ARIZONA DEPARTMENT OF ENVIRONMENTAL QUALITY

Re: Mitigation Order, Docket No: P-50-06 – Review of Aquifer Characterization Report

The Arizona Department of Environmental Quality (ADEQ) has completed its review of the December 28, 2007 Aquifer Characterization report (ACR) submitted by Freeport MacMoRan Sierrita Inc. (Freeport). ADEQ has concerns about the ACR that are described in more detail in the attached comments, but the main concerns are as follows:

GENERAL COMMENTS

I - I' CROSS SECTION SHOWING WATER QUALITY AND HYDRAULIC CONDUCTIVITY DATA SIERRITA TAILING IMPOUNDMENT AREA STA. -90+00.00 TO 50+50.00				SHEET 1 OF 2
	Approved KW	Date 11/29/07	Revised 	Date 	Reference: 7830170A

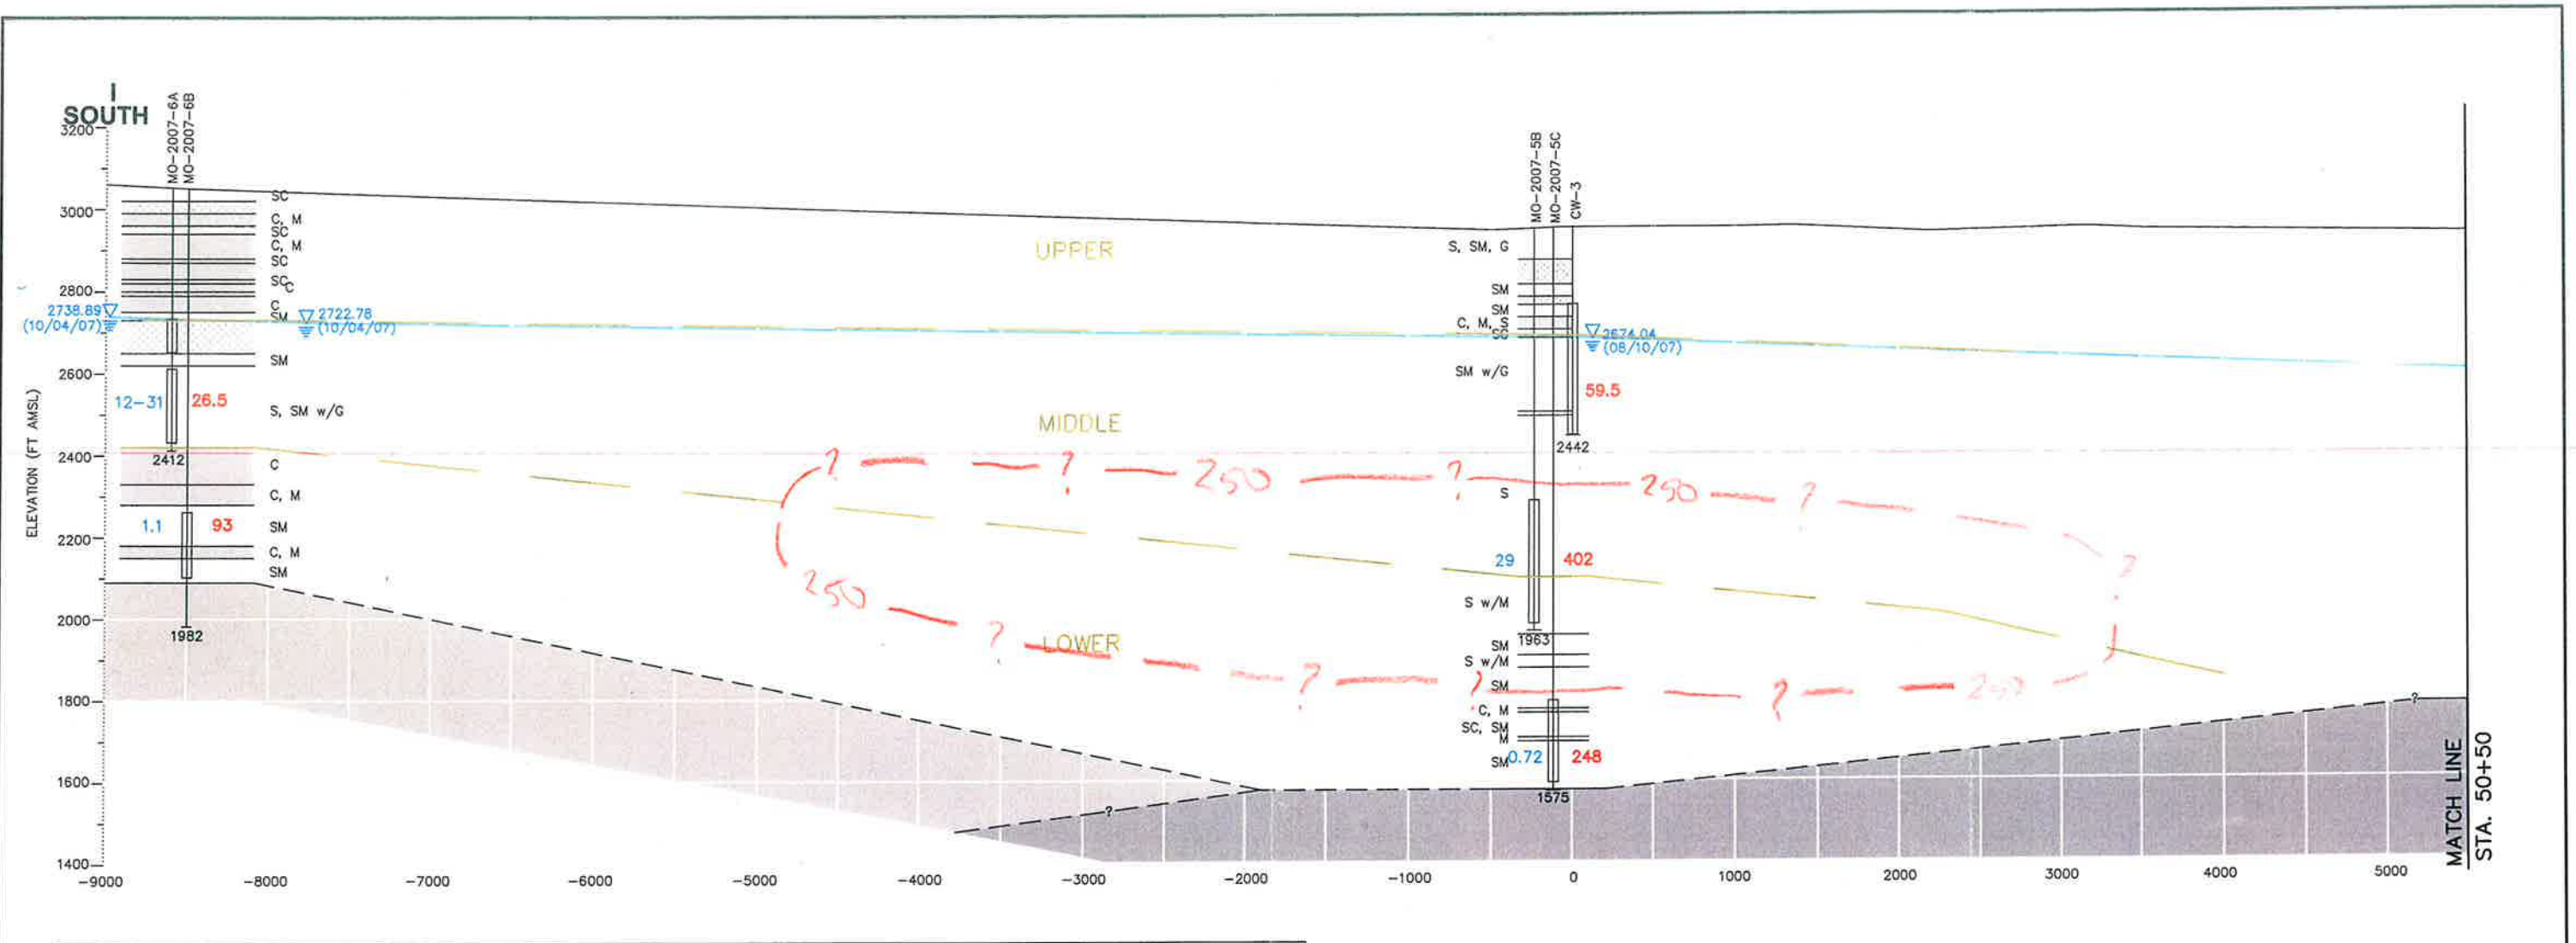
Freeport states in the last sentence of the first paragraph "*The contours on Figures 1 and 4 were developed using the highest measured sulfate concentrations at co-located wells,*" but the report does not provide a rationale as to why the highest concentration of sulfate was used. ADEQ believes it would be more informative to contour the sulfate data per potential hydrostratigraphic units. Freeport also should discuss the vertical distribution of sulfate within the basin fill aquifer, and include cross-sections that post and contour the sulfate data (See Attachments).

ESP-3 — WELL ID
 — WELL
 ▽ WATER LEVEL (DATE)
 1,700 mg/L — SCREEN
 Sulfate concentration contours, queried where uncertain

I - I' CROSS SECTION SHOWING WATER QUALITY AND HYDRAULIC CONDUCTIVITY DATA SIERRITA TAILING IMPOUNDMENT AREA STA. 50+50.00 TO 205+00.00 SHEET 2 OF 2				
	Approved KW	Date 11/29/07	Revised 	Date 	Reference: 7830170A

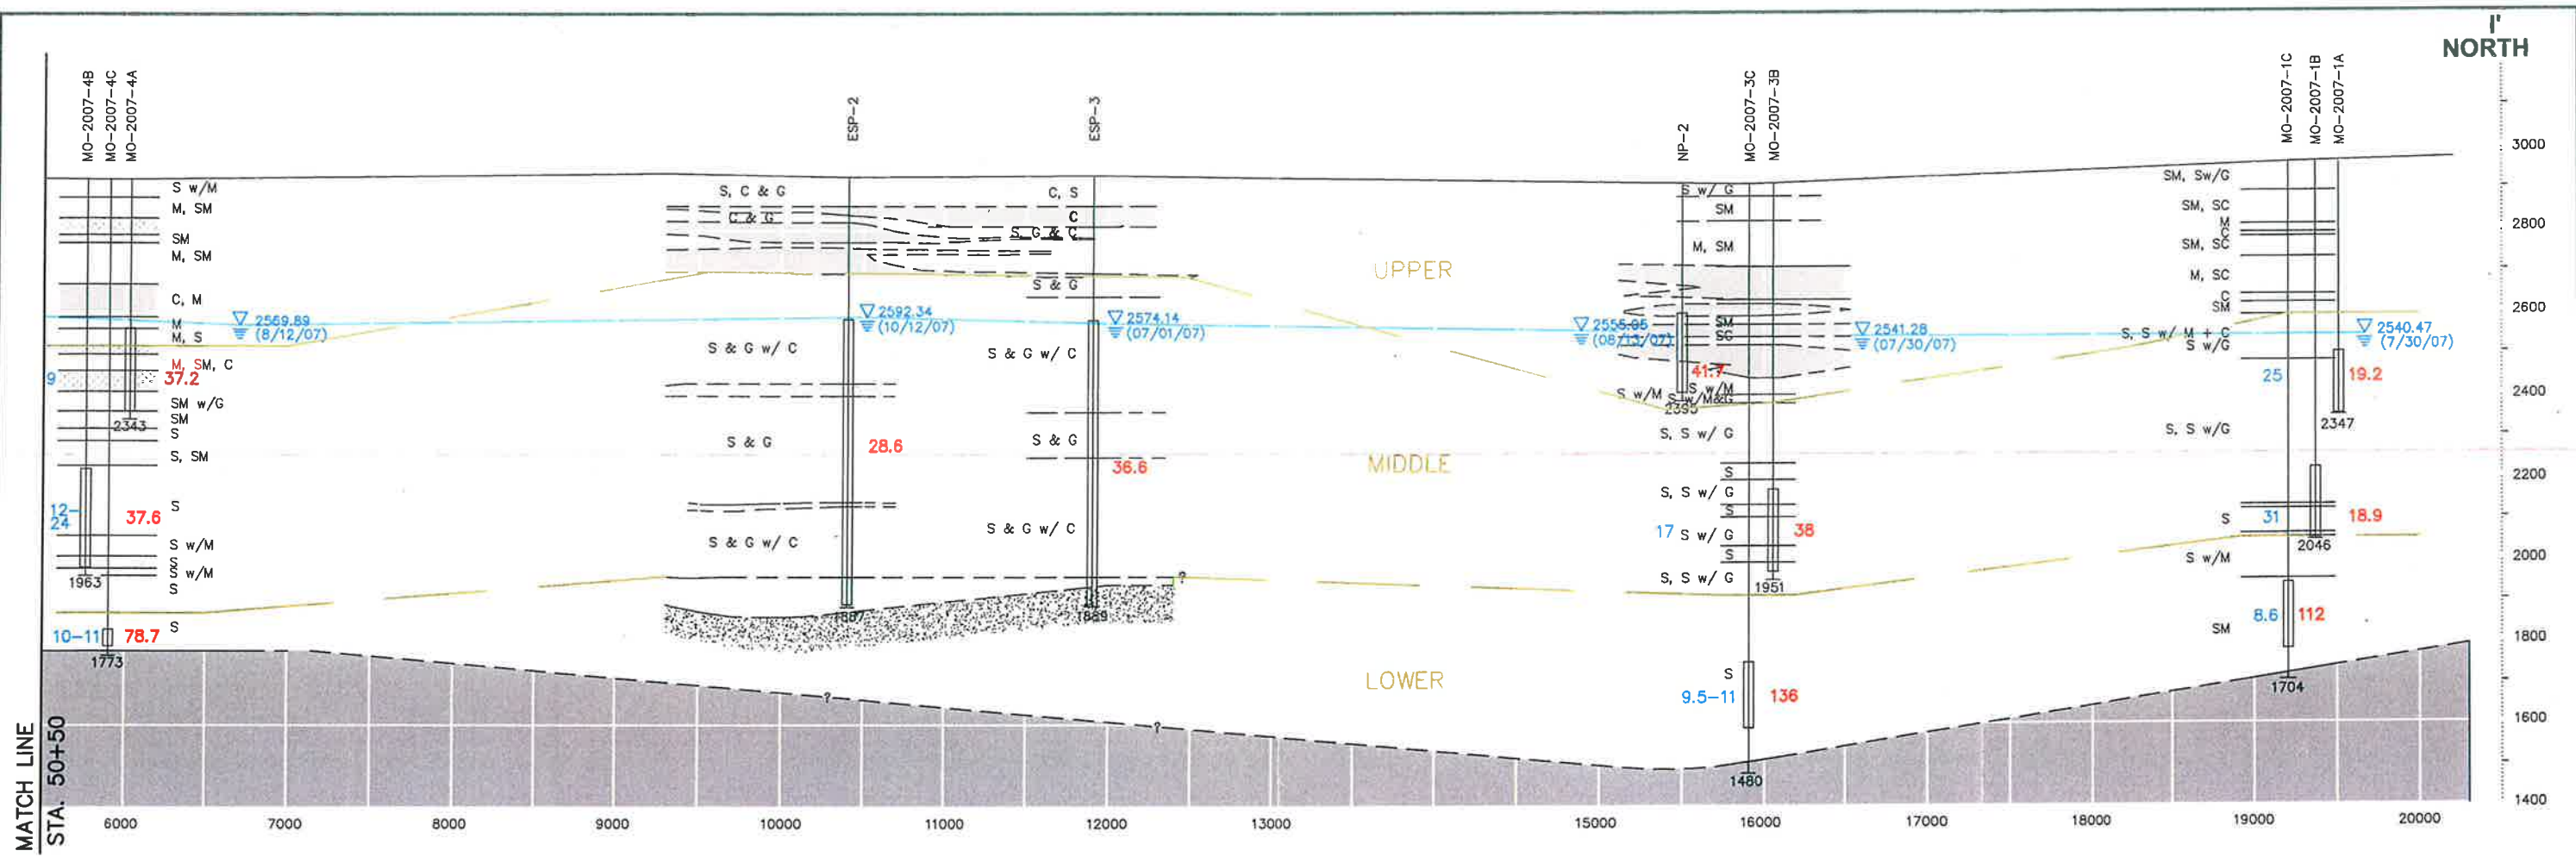
? - 1000 - Sulfate concentration contour, queried where uncertain.

J - J' CROSS SECTION SHOWING WATER QUALITY AND HYDRAULIC CONDUCTIVITY DATA SIERRITA TAILING IMPOUNDMENT AREA

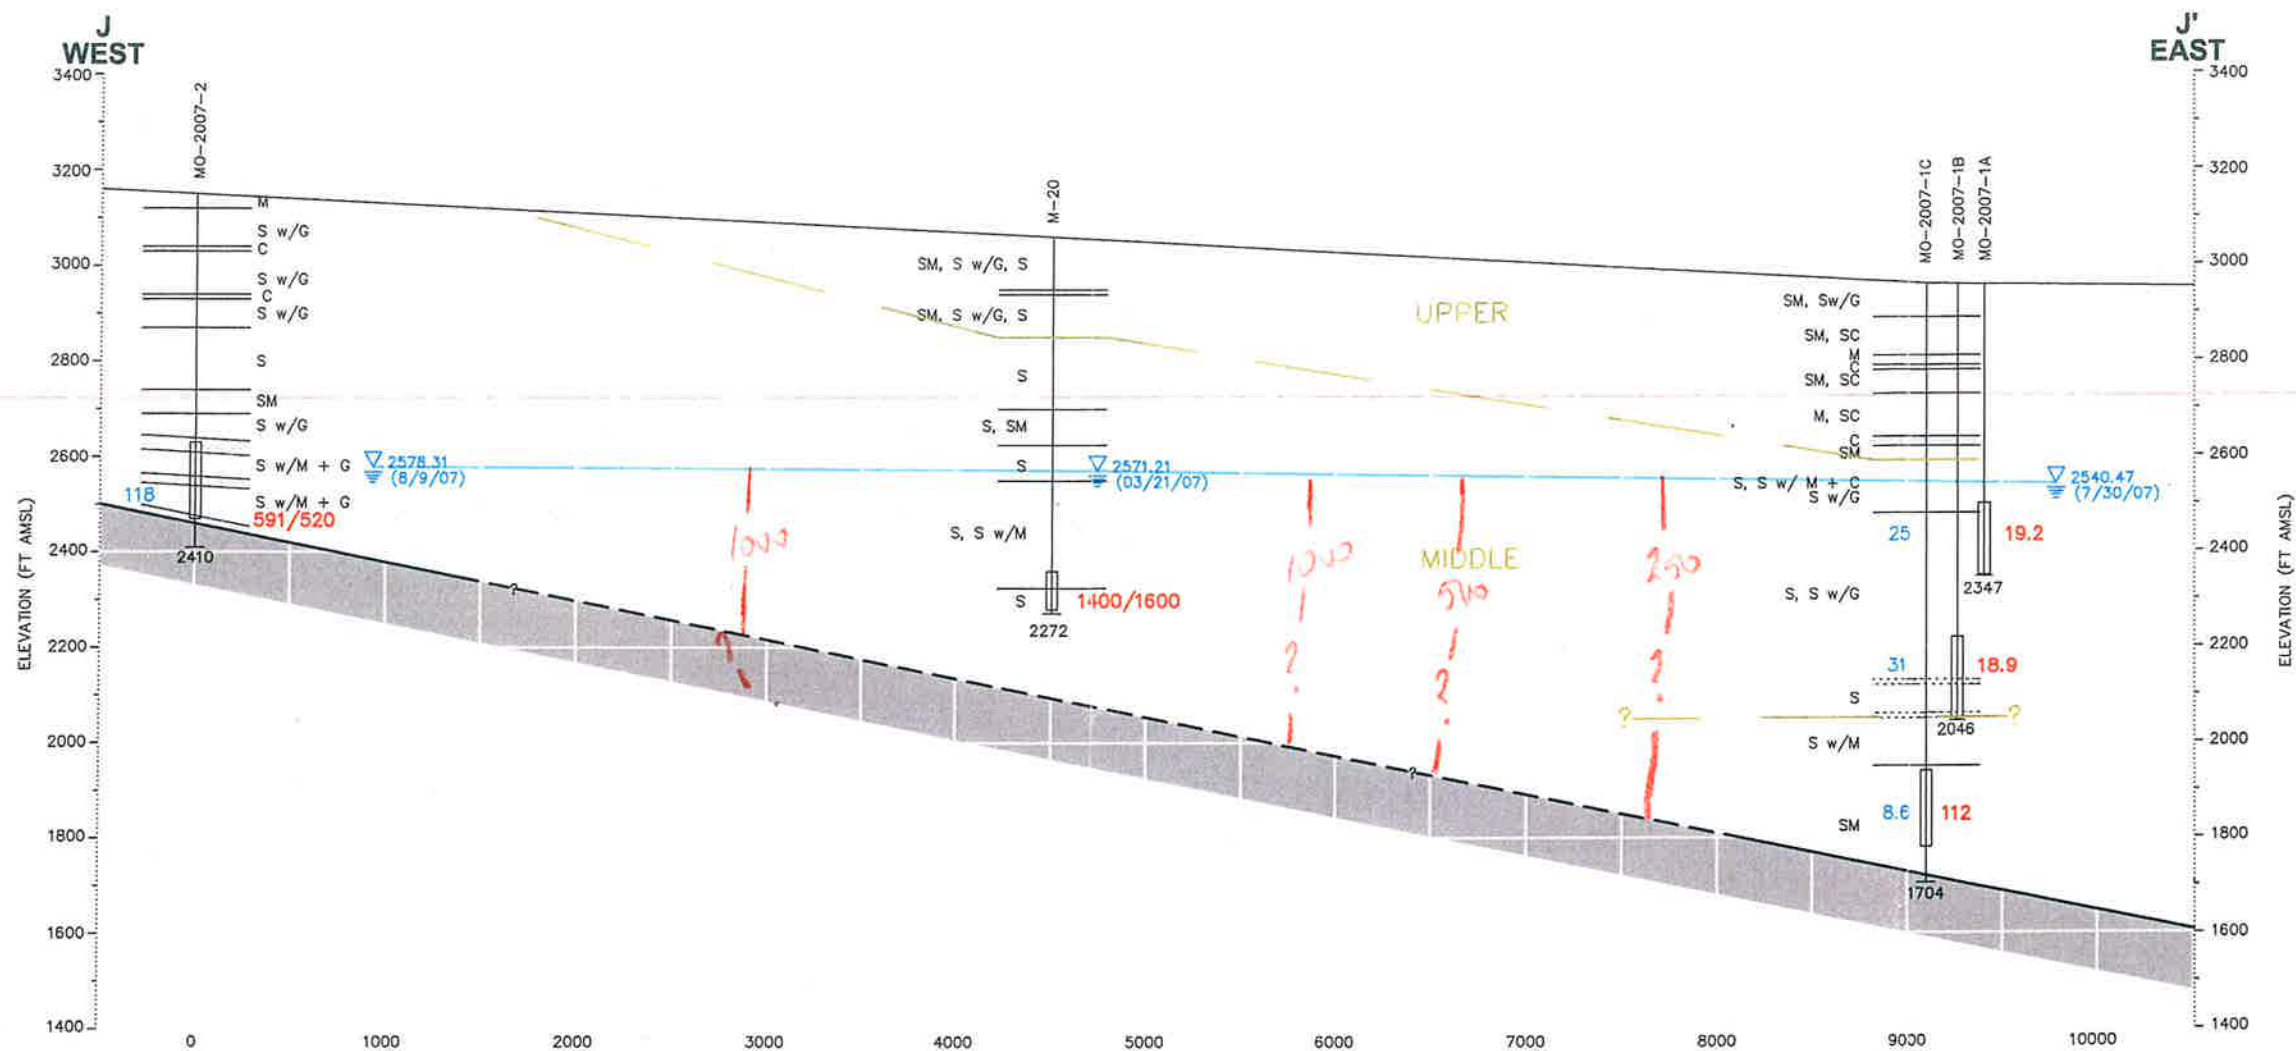
Handwritten note: ? - 1000 - Sulfate concentration contours, queried where uncertain
